Upgrades to John Palmer Public School (SSD-23330227): Evidence relating to Additional on-site carparking in accordance with Condition B2

**Re: John Palmer Public School
SSD 23330227 (20 May 2022) Condition B2**

PROJECT: John Palmer Public School
RE: SDRP– 17th November 2021 – Third Review

Project
John Palmer Public School
85 The Ponds Blvd, The Ponds NSW 2769

Title
LANDSCAPE PLAN

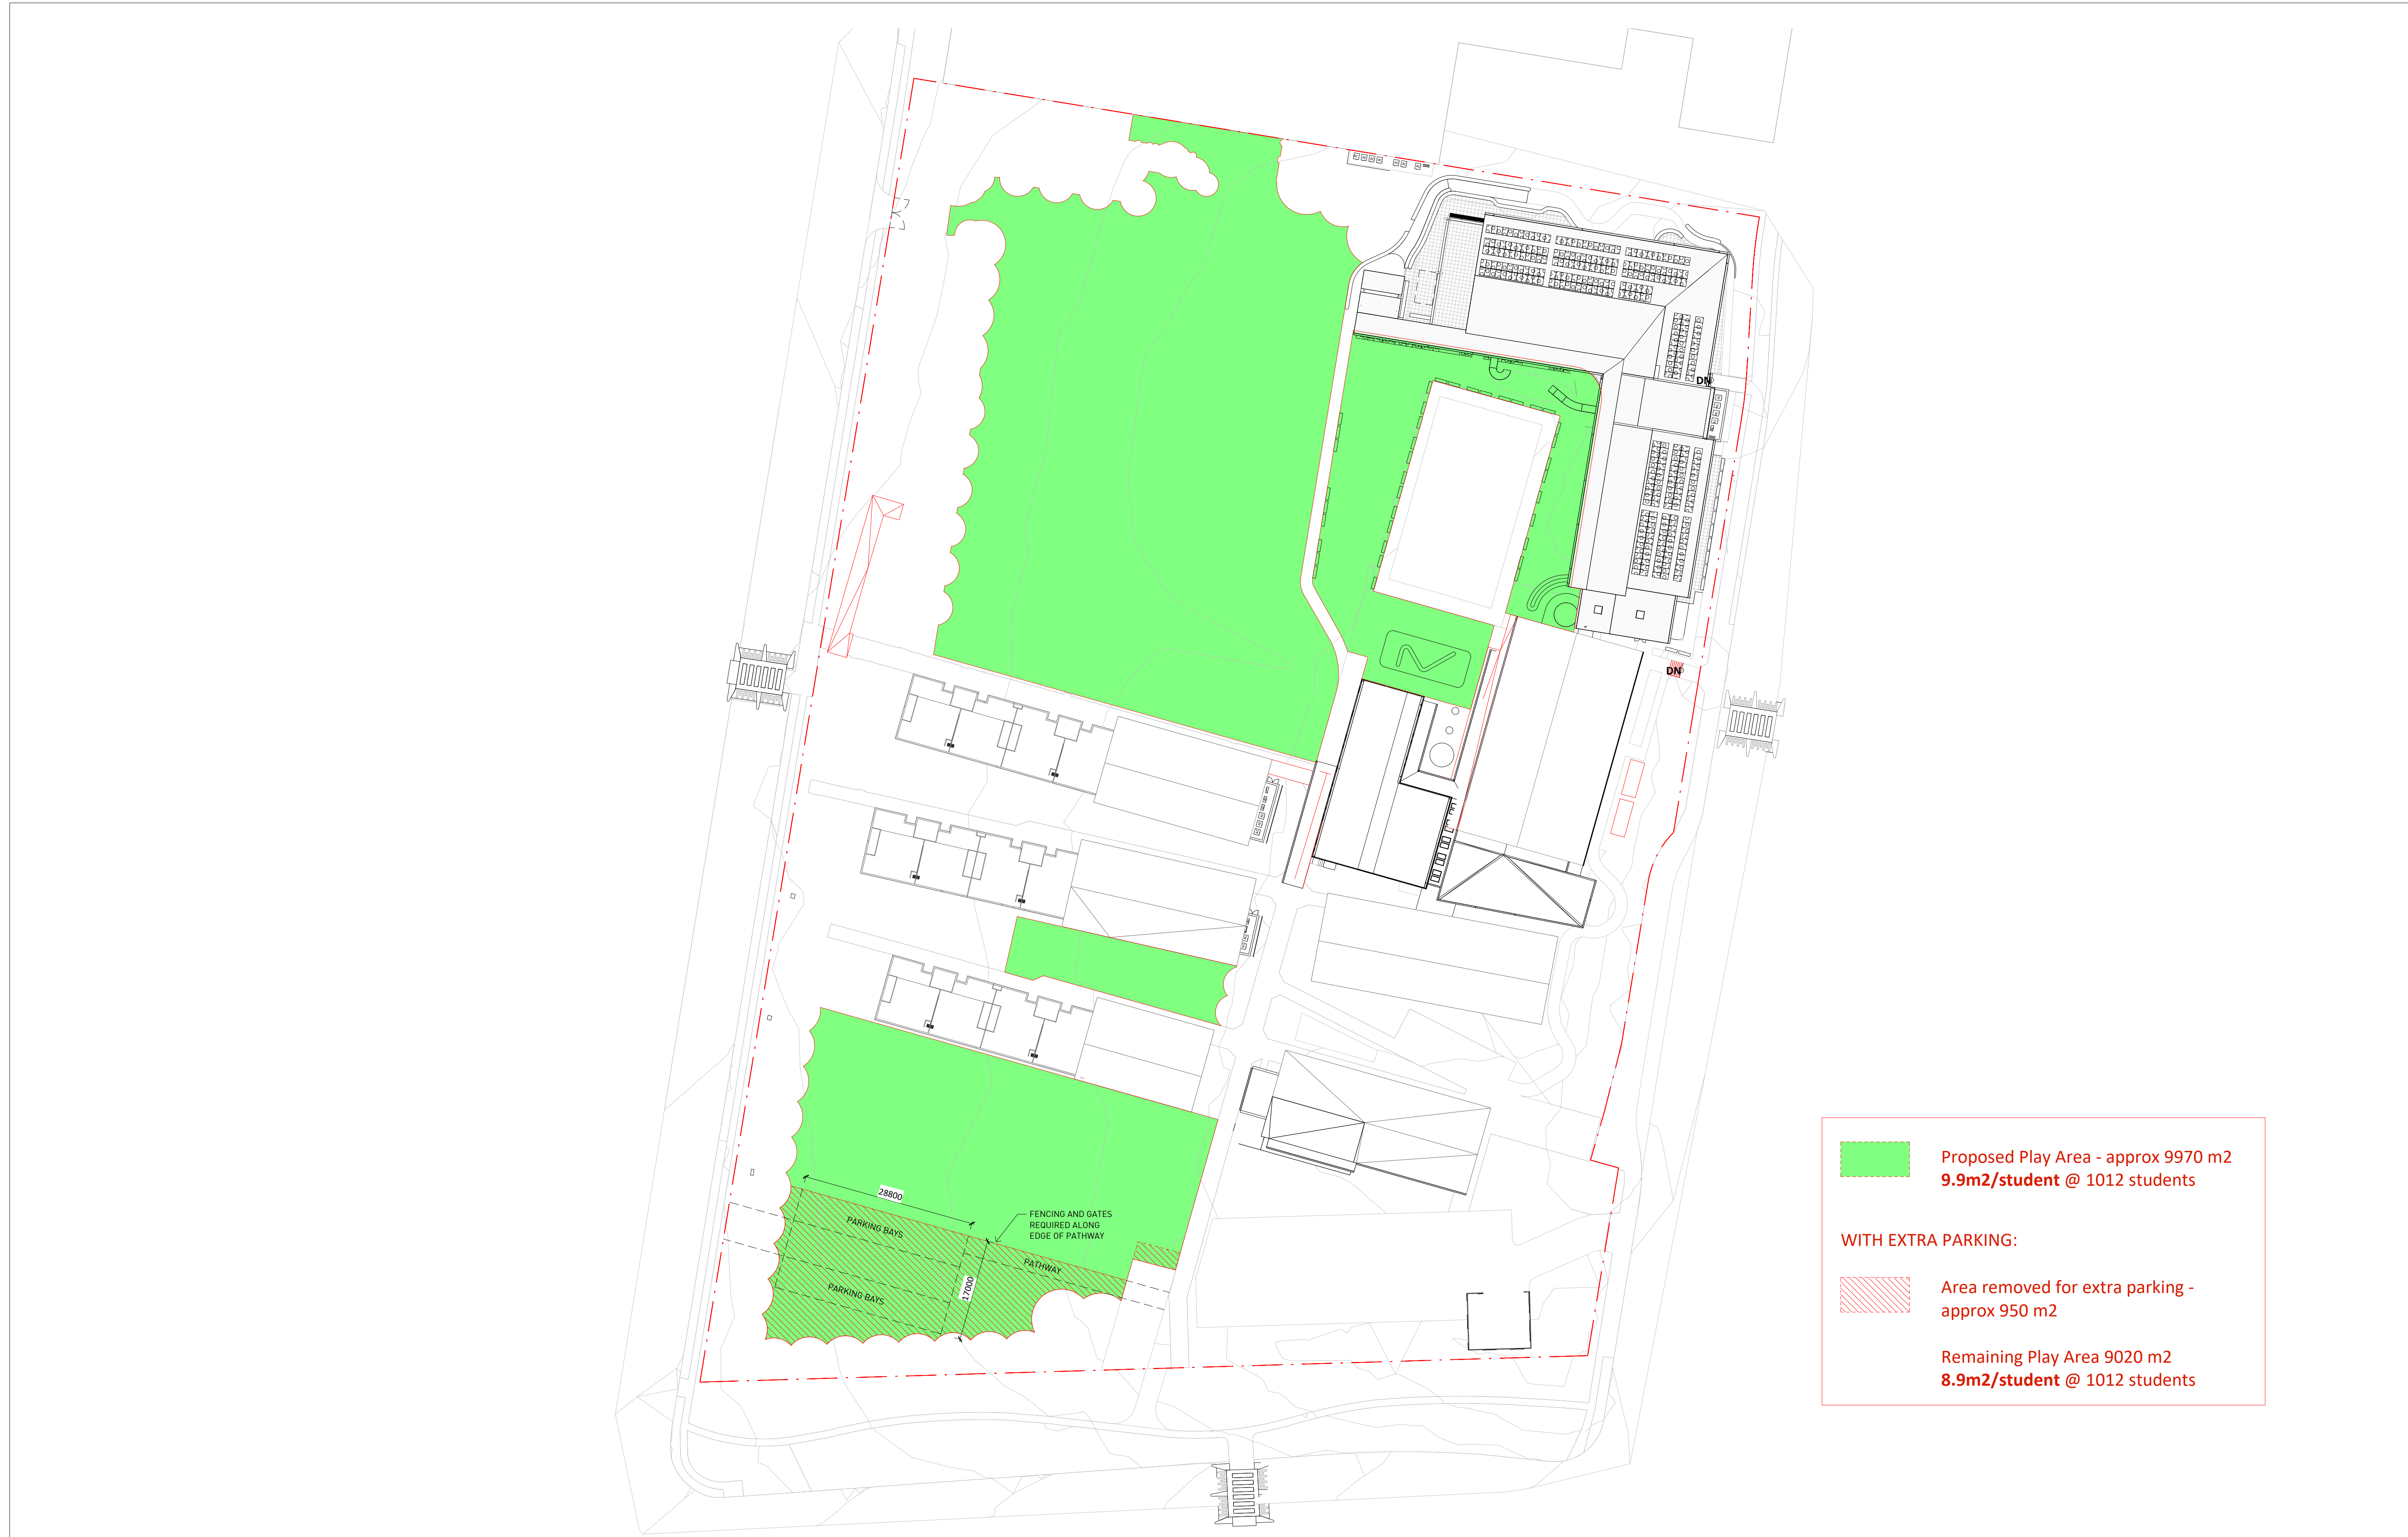
Sketch SK-00-601_01 demonstrates that additional on-site staff car parking required under condition B1 would reduce the amount of the open space per student from 9.9m² per student to 8.9m² per student, which is below the minimum required by the NSW Educational Facilities Standards and Guidelines (EFSG) Design Guide DG10.03 Open Play Space Requirements.

Proposed Play Area - approx 9970 m2
9.9m2/student @ 1012 students

WITH EXTRA PARKING:

Area removed for extra parking -
approx 950 m2

Remaining Play Area 9020 m2
8.9m2/student @ 1012 students
